Appeal the Chief Building Official's Decision for a Sign Variance Application for One First Party Ground Sign

40 Humewood Drive

March 24, 2025

Proposed Sign Details

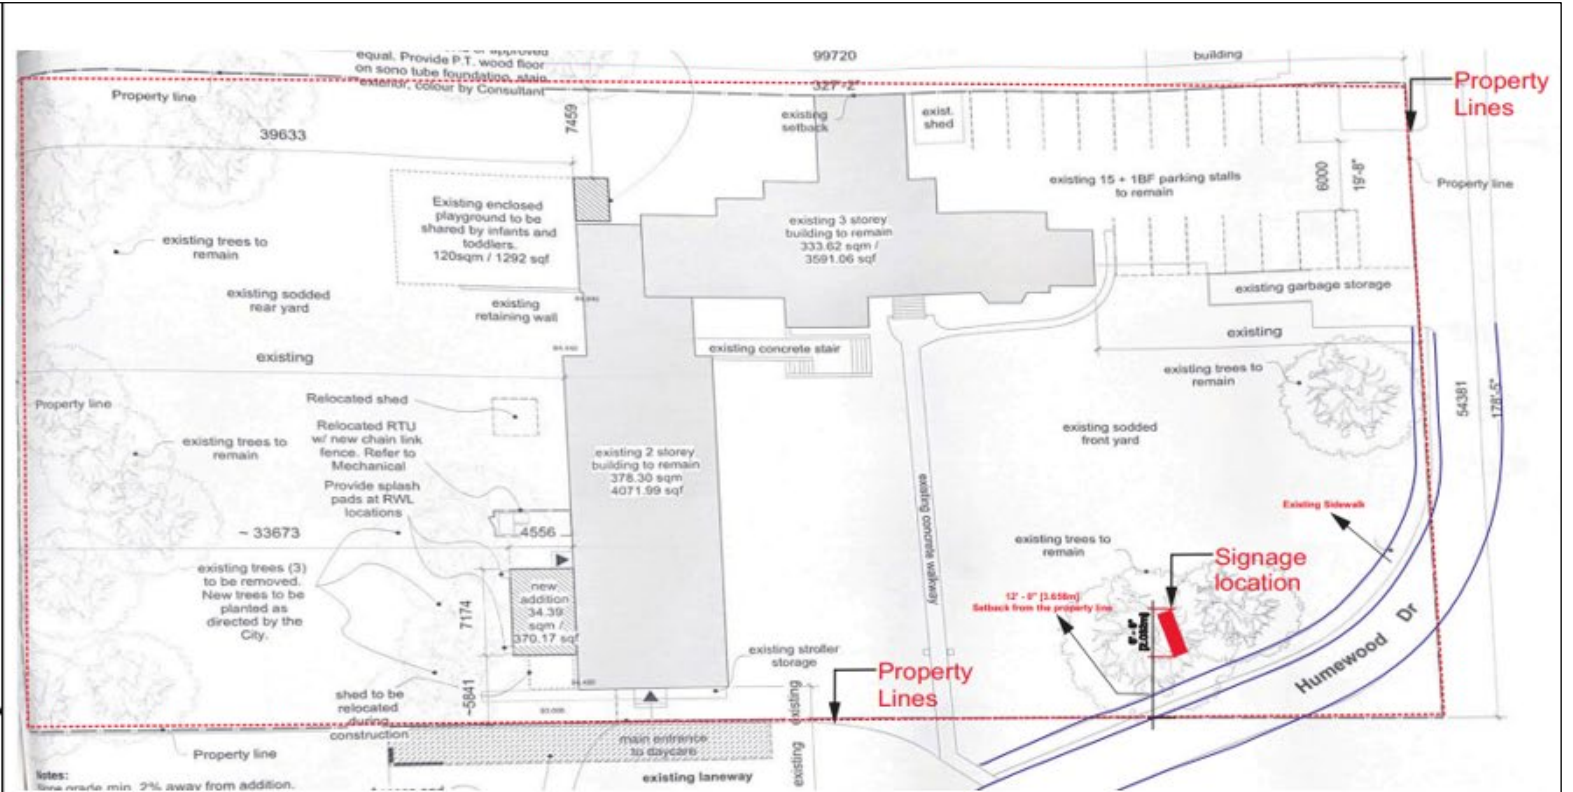
Sign By-Law Reference	Requirement	Proposal
§ 694-21.A(4)(g)[2]	A R-Residential sign district may contain ground sign on a premises containing a school, place of worship, hospital, nursing home or community centre, other than a sign providing direction permitted by Subsection A(3), provided that, should the sign display readograph copy, the readograph copy shall be displayed and changed manually only.	The proposed ground sign would display readograph copy changed electronically.

Sign By-Law Reference	Requirement	Proposal
§ 694-21.A(4)(g)[2]	A R-Residential sign district may contain ground sign on a premises containing a school, place of worship, hospital, nursing home or community centre, other than a sign providing direction permitted by Subsection A(3), provided that, should the sign display readograph copy, the readograph copy shall be displayed and changed manually only.	The proposed ground sign would display readograph copy changed electronically, subject to 5 conditions.

- Condition 1:** Notwithstanding 694-18.E(5), the illumination shall not exceed 150 nits at any time.
- Condition 2:** Notwithstanding 694-18.A(C), the sign shall not be illuminated between the hours of 9:00 p.m. and 7:00 a.m.
- Condition 3:** Notwithstanding 694-14.J, the readograph copy display may only be changed once per day.
- Condition 4:** Evergreen landscaping, at least 1.0 meter in height, shall be installed and maintained in a 1.0 metre radius around the base of the sign.
- Condition 5:** The proposal is to be erected substantially in accordance with the submission materials included as part of the sign variance application.
